IRC — Mechanical

2021 GROUP A PUBLIC COMMENT AGENDA

2021 Public Comment Agenda

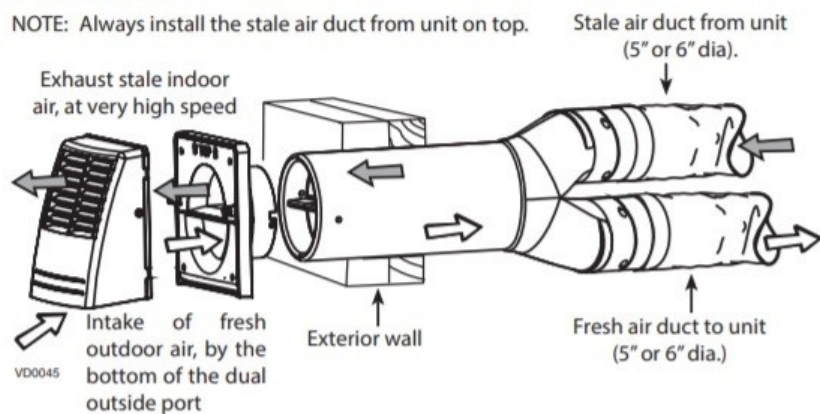
Factory-built intake/exhaust combination termination fittings are regularly provided by fan manufacturers and installed by builders to separate mechanical air intakes from mechanical exhaust serving dwelling unit or sleeping unit mechanical ventilation systems. The included image from a fan manufacturer's installation instructions provides an example of a typical fitting serving this purpose.

The IRC Mechanical committee's approval of RM12 as submitted aligned with the 2018 IMC's Sections 401.4 and 501.3.1 approval of the use of "*approved* factory-built intake/exhaust combination termination fittings" to separate the air streams associated with mechanical intake air openings and living space exhaust air, when the fitting is provided in accordance with the fan manufacturer's instructions. Similarly, Section G2407.1 of the Fuel Gas Code (see below for reference) approves the use of concentric vent termination fittings to separate combustion air from flue gases provided that such fittings are installed "in accordance with the appliance manufacturer's instructions"; the primary difference between the 2018 IMC and the Fuel Gas Code in this respect is that the Fuel Gas Code does not require special approval for concentric vent termination fittings.

By approving M16 as submitted, the IMC Committee removed the requirement for factory-built intake/exhaust combination termination fittings to be "approved" when such terminations are installed in accordance with the "appliance" manufacturer's instructions (based on feedback received since the hearings, a PC will be submitted to M16 to change the word "appliance" to "fan" to better clarify that such terminations must be recognized by the fan manufacturer to be provided without special approval). This action aligned the 2024 IMC requirements for factory-built intake/exhaust combination termination fittings with the Fuel Gas Code's treatment of concentric vent termination fittings (i.e., no special approval is required when installed in accordance with the appliance/fan manufacturer's instructions). Approval of this public comment to RM12 and approval of M16 as modified with the PMGCAC's public comment will align the 2024 IRC, 2024 IMC, and 2024 FGC in this regard.

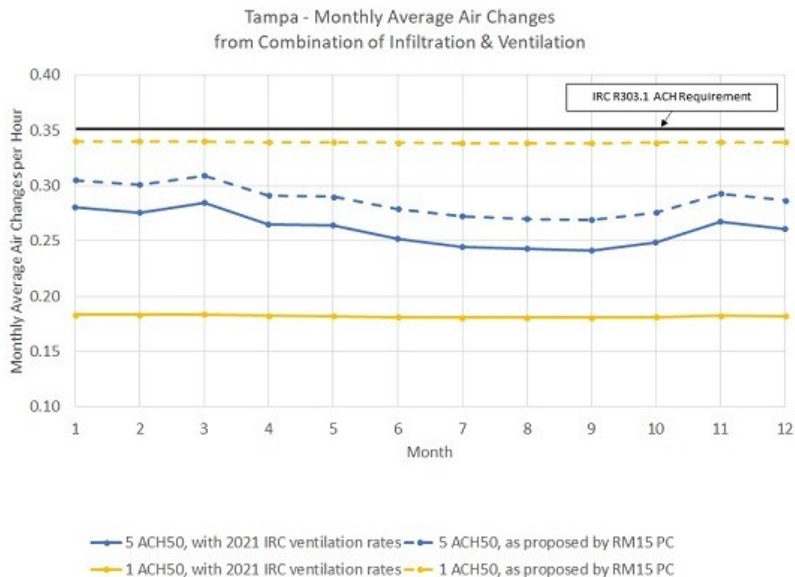
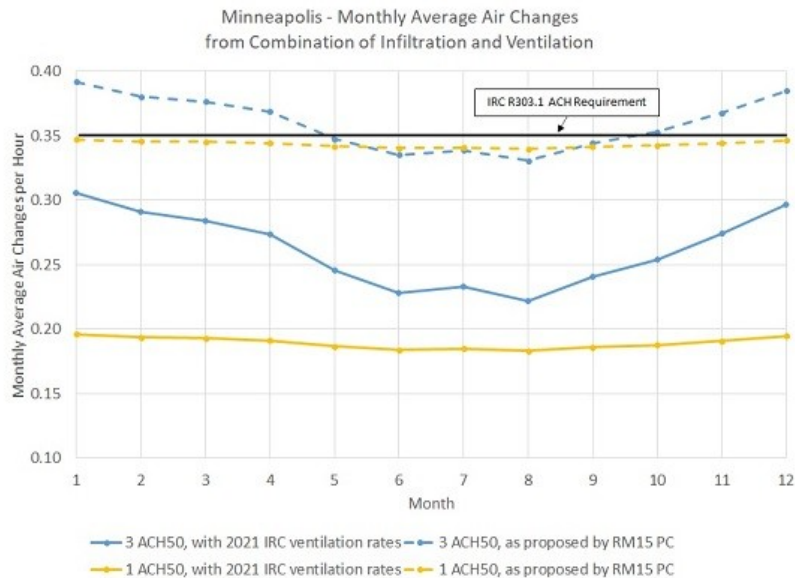
Commenter's Reason: The committee's statement that this proposal requires a blower door test is incorrect. The method is based on a *design* air leakage rate that does not require a blower door test. If no design air leakage rate is provided by the builder or design professional, the design air leakage rate defaults to what is specified in Chapter 11 (see footnote a to the proposed Table M1505.4.3(1) for more information. Tightening a home's envelope without simultaneously increasing ventilation will inevitably increase the concentration of pollutants generated indoors. To maintain acceptable indoor air quality (IAQ), the minimum ventilation rate should therefore increase as a home's leakage rate decreases. As pointed out during the committee action hearings, it is unfortunate that maintaining acceptable IAQ generally requires energy use for conditioning and sometimes for dehumidification. However, the code's purpose is to "establish minimum requirements to provide a reasonable level of safety, health and general welfare", even when such measures require energy.

The committee requested more information be provided regarding the affect of airflow rates on health and welfare. Studies that have shown better health outcomes for building occupants as a function of higher ventilation rates include:

To keep concentrations of indoor air pollutants in check, ventilation rates should increase as homes get tighter. Studies have shown improvements in health outcomes with increasing ventilation rates. The ventilation rate required by the IRC M1505.4.3 is far lower than European rates, ASHRAE 62.2 rates, and even the rate required by IRC Section 301.1.1. Approval of RM15 as modified by this public comment will provide a rational and scalable air change rate for tightly constructed homes.
